Addendum No. 2
March 20, 2026

Project: Union County Courthouse Addition and Renovation
Elk Point, South Dakota
Architecture Incorporated Project Number 0728.2893.20

Architect: Architecture Incorporated

A COURTHOUSE - EAST ELEVATION
 SCALE: 1/8" = 1'-0"

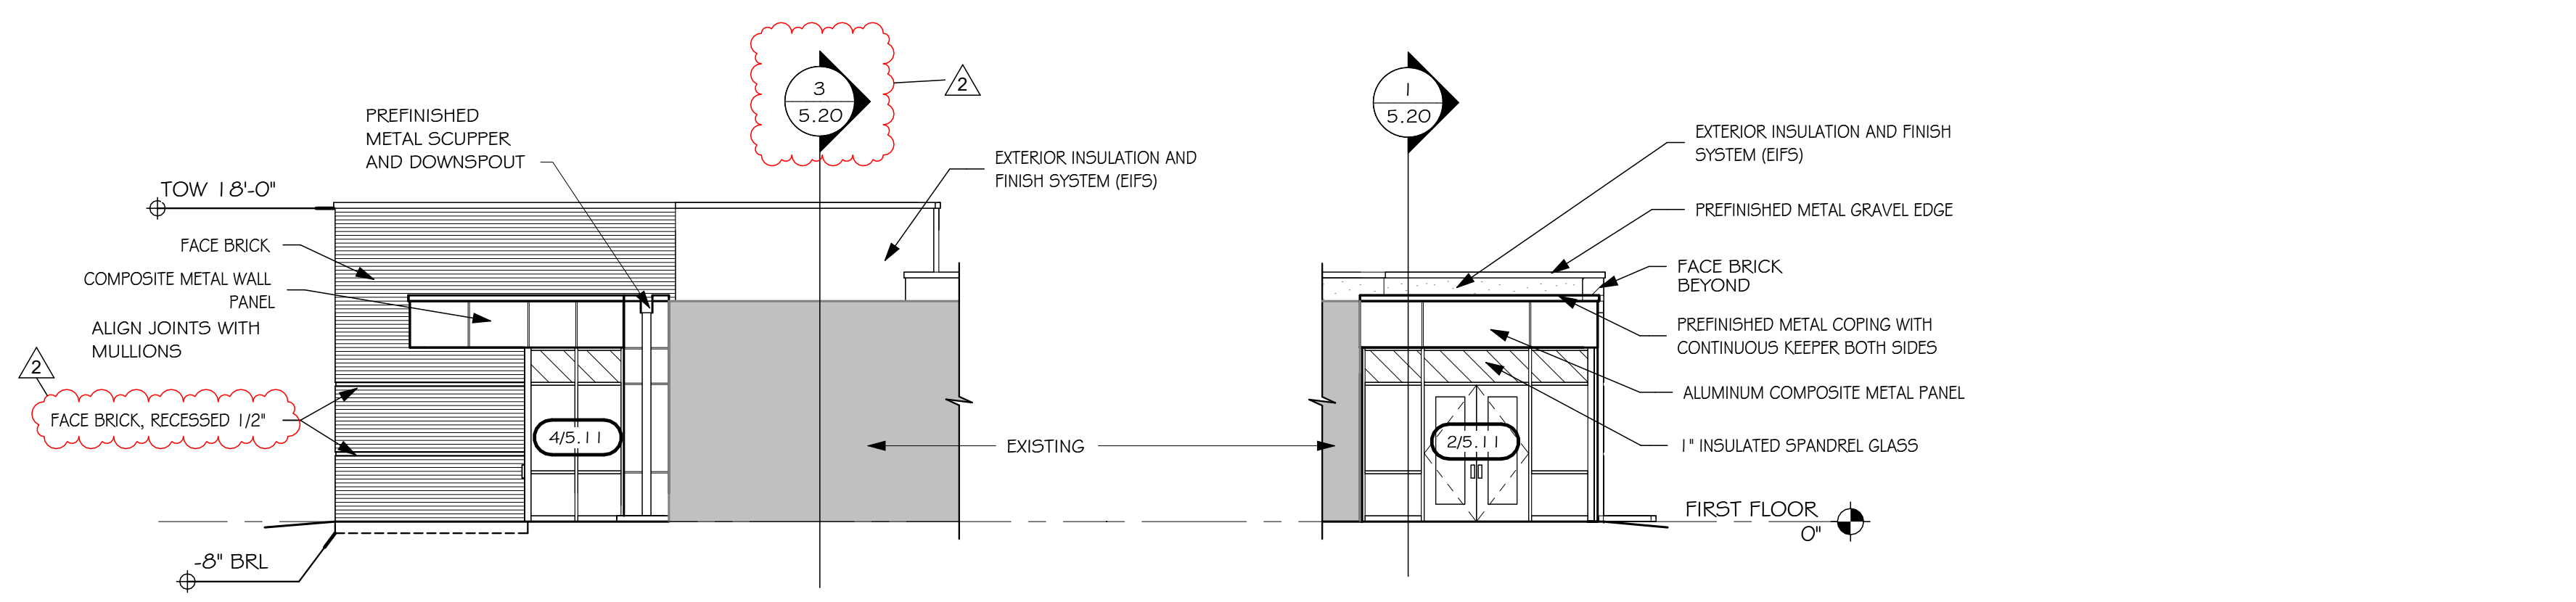
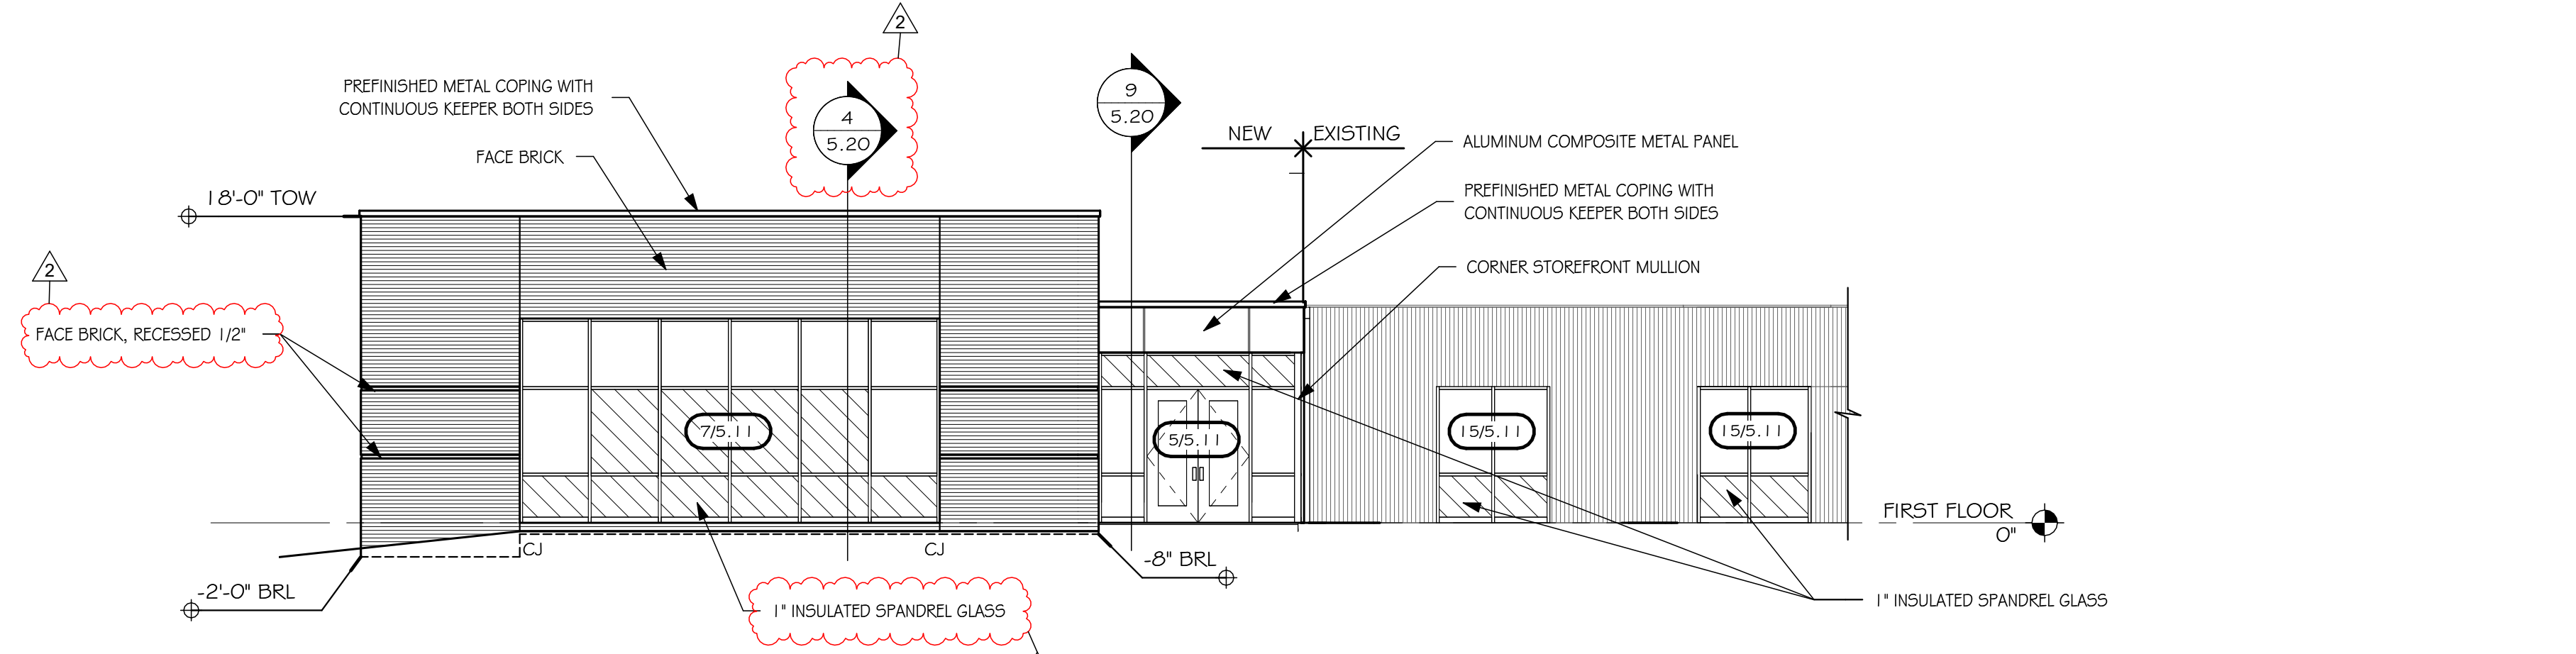
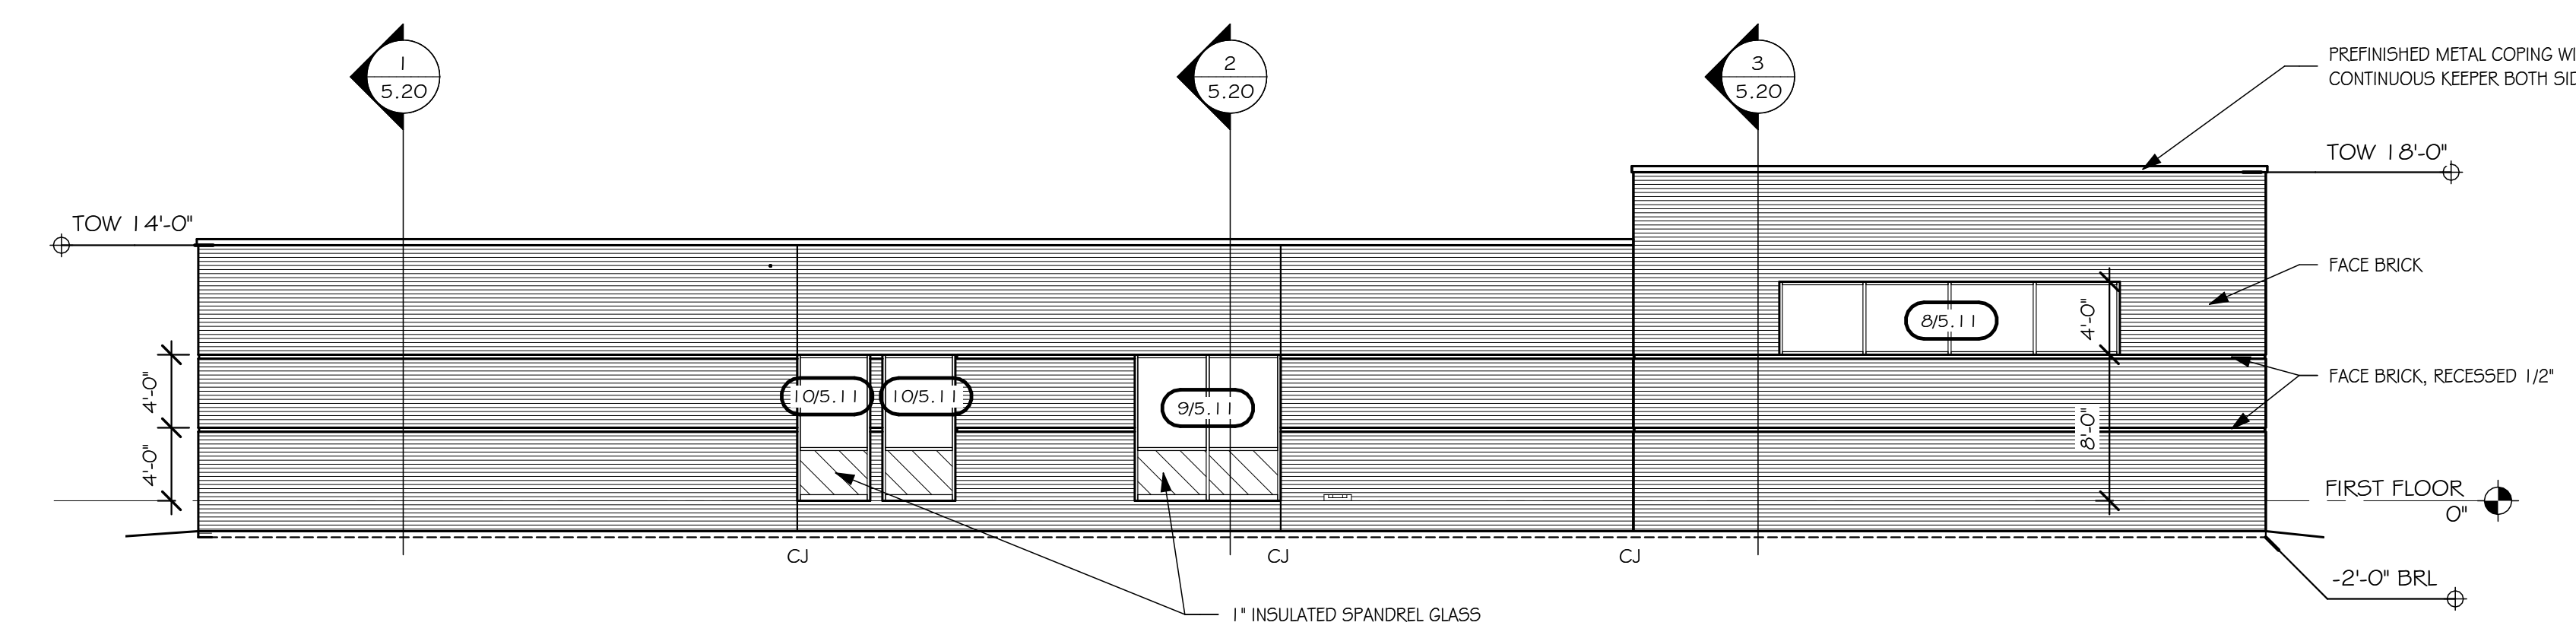
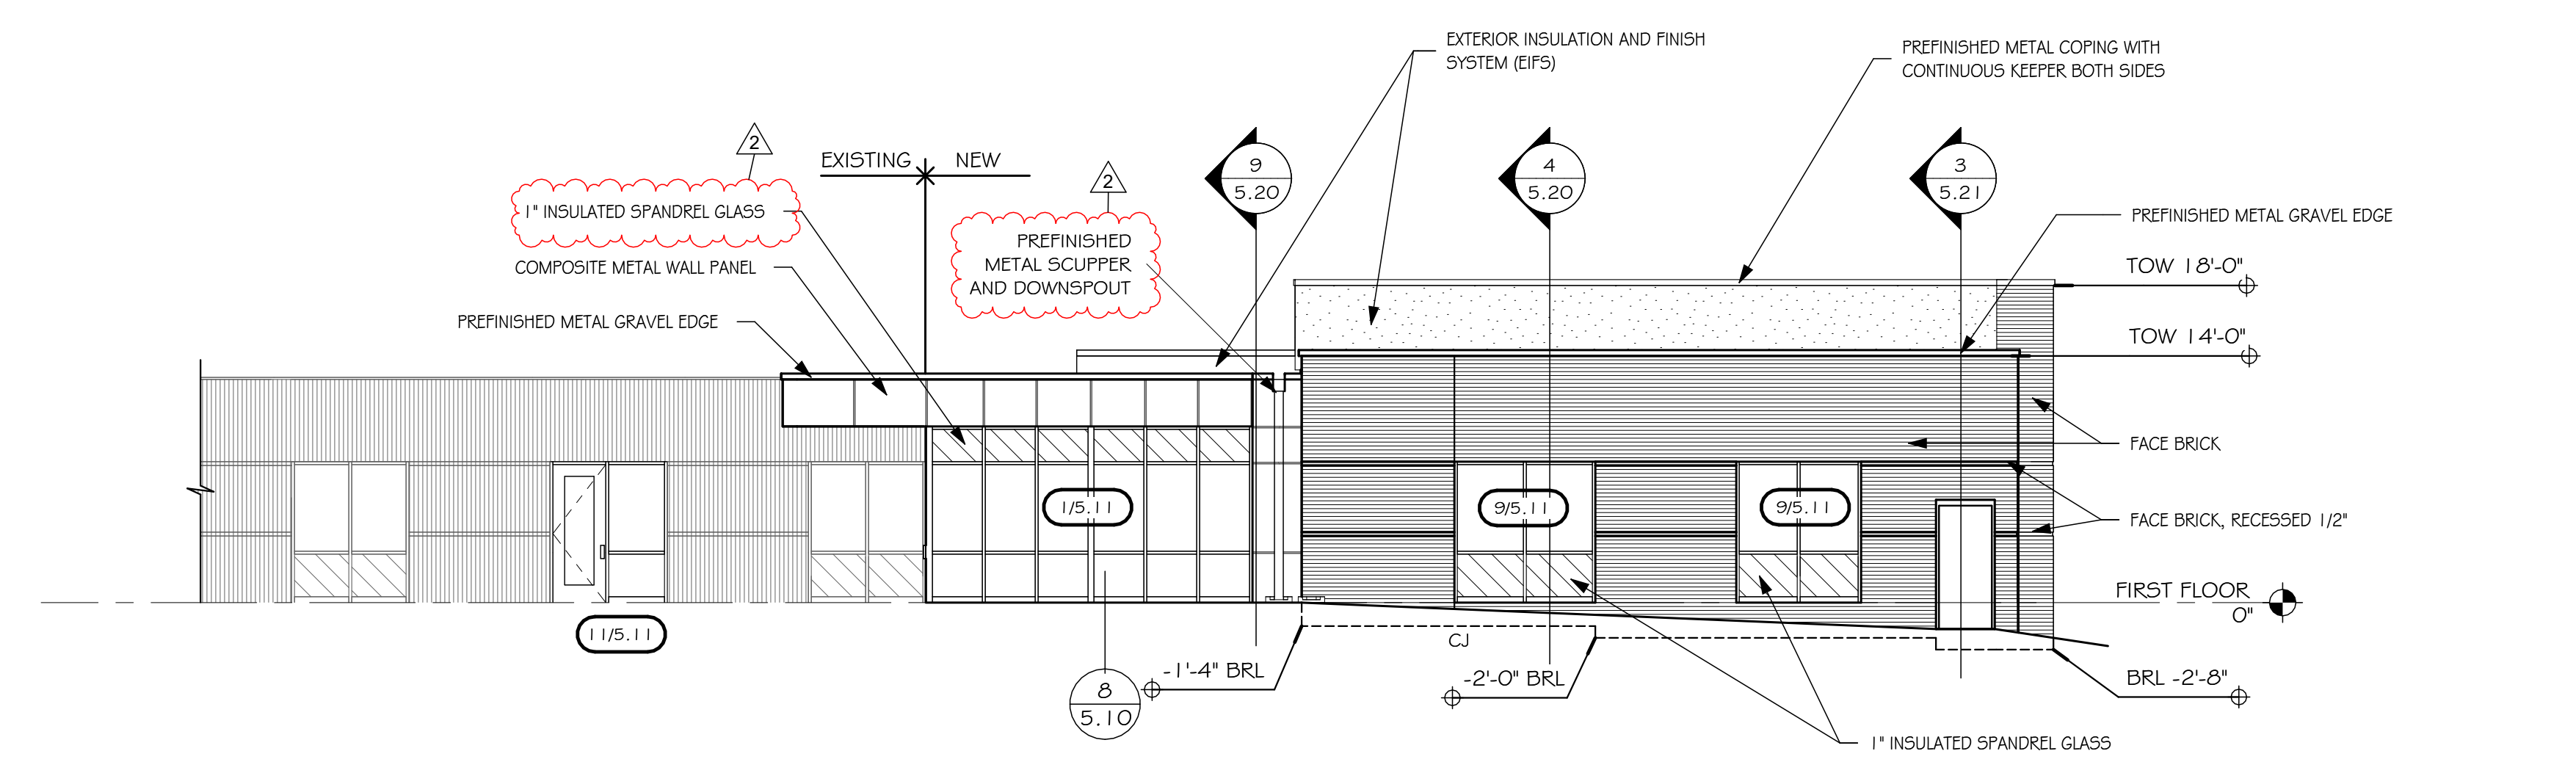
- a. See attached revised Drawing Sheet 5.10 at elevations for modifications to face brick veneer and insulated spandrel glass.
 - b. See attached revised Drawing Sheet 5.10 at opening details, revising inclusion of weather barrier and extents within respective assemblies.

ROOF PLAN

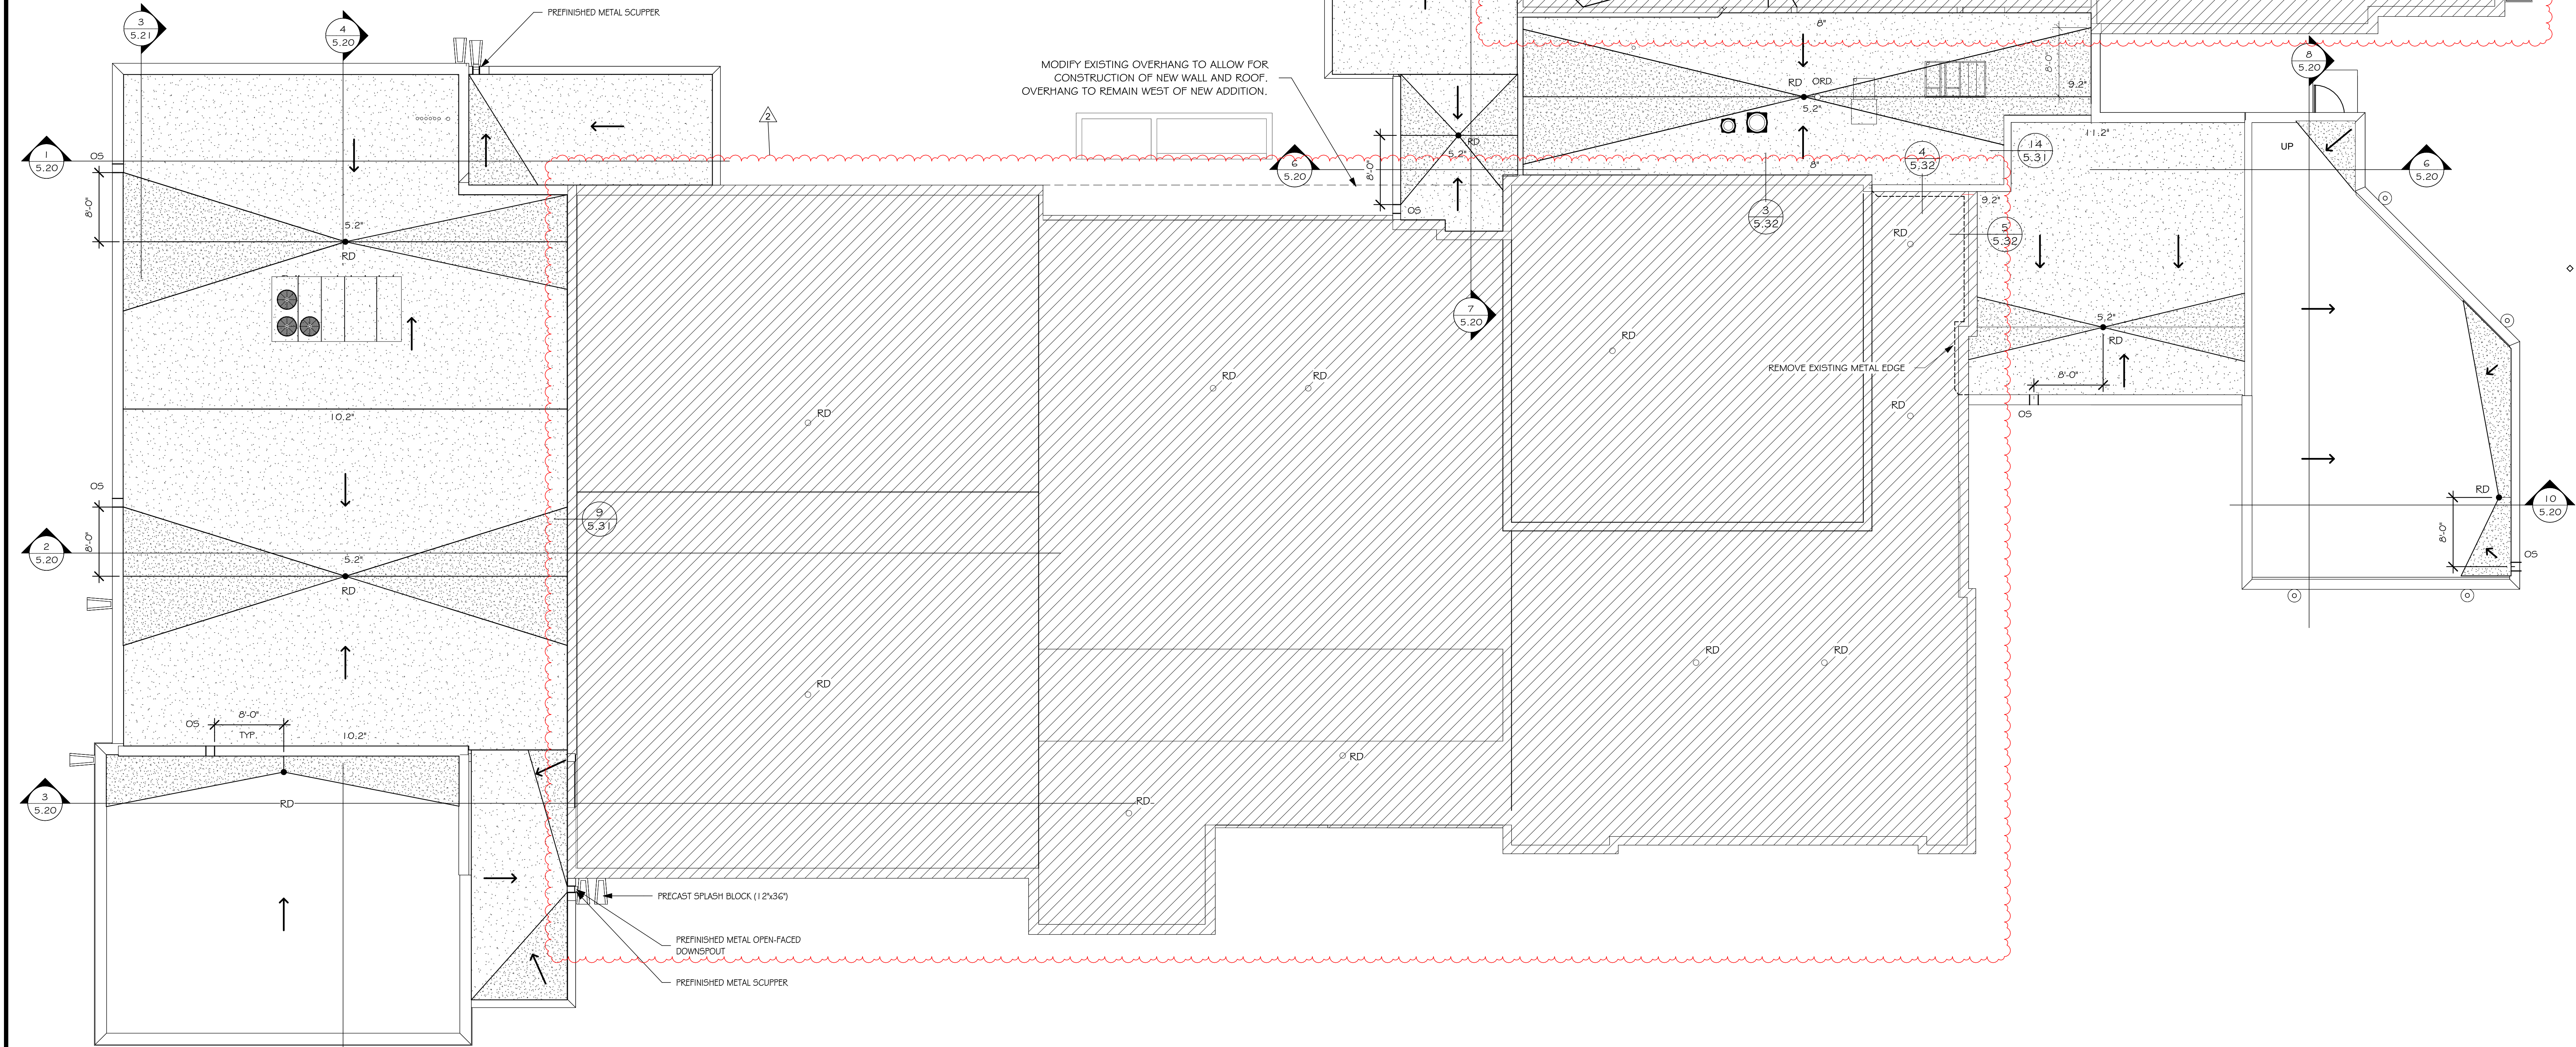
8. DRAWING SHEET 5.50 – ROOF PLAN
 - a. See attached revised Drawing Sheet 5.50, adding a hatched region that delineates existing roof membrane to remain.
